PROPOSED DEVELOPMENT AT BOHERBOY, SAGGART, CO. DUBLIN

Road Safety Audit Stage 1/2

Project Title	Proposed Development at Boherboy, Saggart, Co Dublin
Project No.	25201-01
Document Title	Road Safety Audit Stage 1/2
Document No.	25201-01-001

Figure 2.12 – Drainage

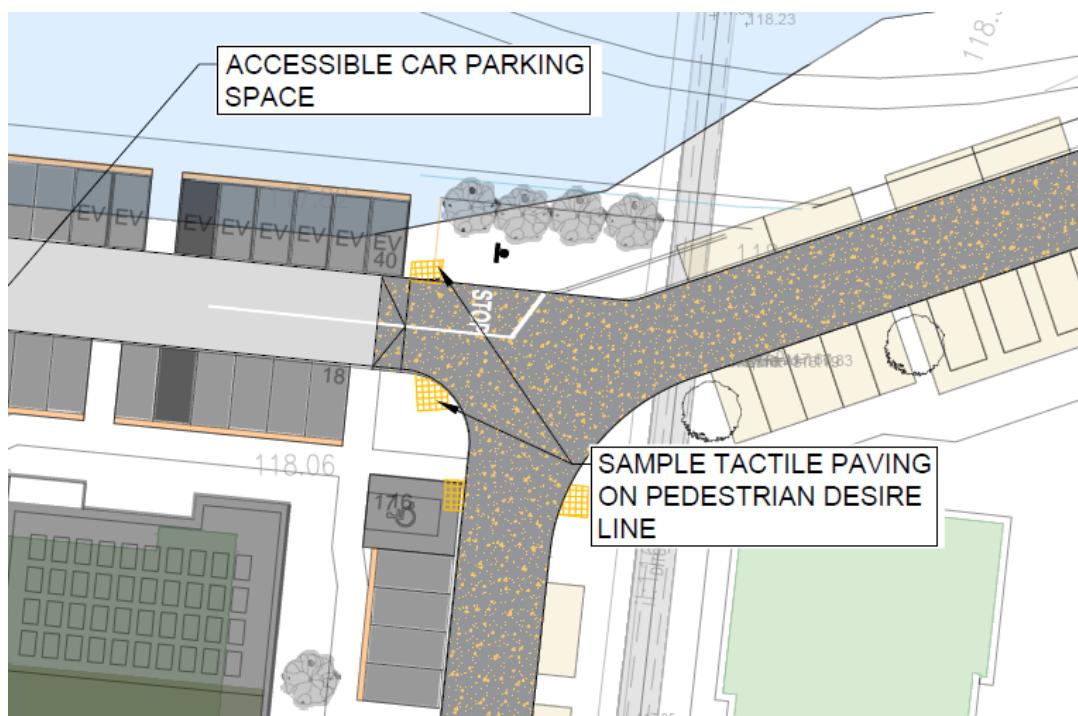
Various locations feature grade transitions between carriageways and raised streets/tables/crossings. It is unclear if drainage measures will be adequate and ponding of water and associated silting may result in slipping hazards for cyclists.

Recommendation: Ensure Adequate drainage that is sympathetic to the needs of cyclists.
